APPLICATION NO.	FILING DATE	FIRST NAMED INVENTOR	ATTORNEY DOCKET NO.	CONFIRMATION NO.
09/618,497	07/18/2000	Yu Zheng	PAT-1238-DIV	9055

Office Action Summary

DETAILED ACTION

FIG. 3

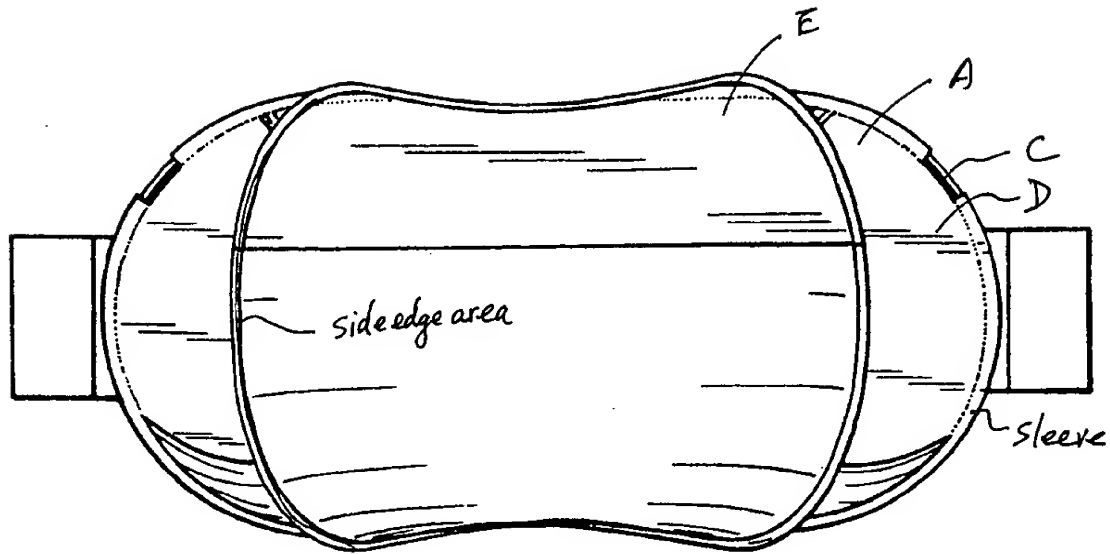
McLeese '407 (see attachment attached with prior art office action) teaches a collapsible structure comprising a single first base panel (A) having a foldable frame members (C) partially covered by a fabric material (D) through a sleeve, a single second upper panel (E) having a foldable frame members (F) partially covered by a fabric material (G) through a sleeve, wherein the second upper panel having two opposite end edges (B) being coupled to the opposite side of the outer periphery of the first base panel by interconnecting pieces (H) such that the first base and second upper panels define an interior space therebetween, and the second panel (E) has a front edge between two opposite end edges defining an opening for ingress and egress to the interior space. Although McLeese does not define the opposite end edges of the second upper panel each being coupled to the outer periphery of the first base panel by an interconnecting piece that causes the end edges of second upper panel spaced apart and extending beyond the outer periphery of the first base panel. Zheng teaches a collapsible structure comprising a single first base panel (72a) having an outer periphery, a second upper panel which is formed by a plurality of sections (72b-72e) having opposite end edges (80a, 82a), wherein the opposite end edges (80a, 82a) of the second upper panel are coupled to the opposite sides (74a, 74c) of the outer periphery of the first base panel by interconnecting fabric pieces (i.e., 37, 37a, 37b) such that the opposite end edges of the upper panel being connected to and extending beyond the outer periphery of the base panel to define two extensions between the base and the upper panels and to define an enlarged interior space therebetween. It would have been obvious to one of

ordinary skill in the art at the time the invention was made to modify the collapsible structure of McLeese having the opposite end edges of the upper panel being coupled to the opposite edges of the lower panel by interconnecting fabric pieces as taught by Zheng, as old and well known connecting concept, for allowing the edges of the upper panel being spaced apart secured to and also extended beyond the outer periphery of the base panel to provide a larger interior space area as desired.
